Office Action Summary

10/813,242

DETAILED ACTION

Fig. 3

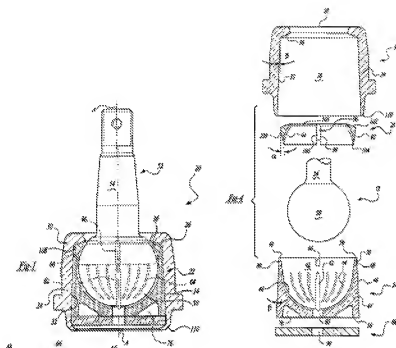
With respect to claims 1, 3 and 4, Maughan discloses a joint assembly (20, Figs. 1, 4) including a metal housing (30) having a side wall (34) which defines a central bore having a closed end via a washer (88) and an open end, the metal housing having an axial lubrication port

(90) in the closed end (88) of the central bore; a metal lower bearing (24, shown with a metal cross-hatching) disposed within the central bore adjacent the closed end, the metal lower bearing (24) including a lubrication slot (60) disposed on an inner bearing surface, the lubrication slot (60) being generally axially aligned with the central lubrication port (90) in the metal housing (30) to provide a common lubrication passageway; a metal moveable member (52) having a head end portion (50) disposed in the central bore and a shank portion (54) extending from the head end portion (50), the head end portion (50) engaging the central bore of the metal housing (30), the shank portion (54) being at least partially disposed outside of the central bore; an annular metal upper bearing (26) disposed about the movable member (52) within the central bore, the annular metal upper bearing (26) having an inner surface engaging the head end portion (50) in direct metal-to-metal sliding contact, and outer surface directly engaging the side wall (34), and a split segment (96) extending from the inner surface to the outer surface; and wherein the annular metal upper bearing (26) is configured to engage the side wall (34) and the head end portion (50) simultaneously. Maughan fails to disclose an annular cover plate disposed about the movable member and secured within the central bore; and a spring member compressed between the annular cover plate and an upper surface of the annular upper bearing; the annular cover plate and spring member are composed of metal, and wherein the spring member exerts an axial preload force on an annular metal upper bearing (constituted by an inner surface of the housing 10) with toward the closed end of the central bore, and a head end portion (12a) simultaneously. Graham et al. teach a ball joint (Fig. 2) that includes an annular cover plate (15) disposed about the movable member (12) and secured within the central bore; a spring member (14) compressed between the annular cover plate (15) and an upper surface of the annular upper bearing (13); the annular cover plate (15) and spring member (14) are composed of metal, and wherein the spring member (14) exerts an axial preload force on the annular metal upper bearing (13) toward the closed end of the central bore, and the head end portion (12a) simultaneously. It would have been obvious to one of ordinary skill in the art at the time of invention was made to provide the ball socket joint of Maughan with a metal cover plate and a metal spring as taught by Graham et al. in order to urge the bearing wall of the bearing ring to maintain it against the ball end of the stud.
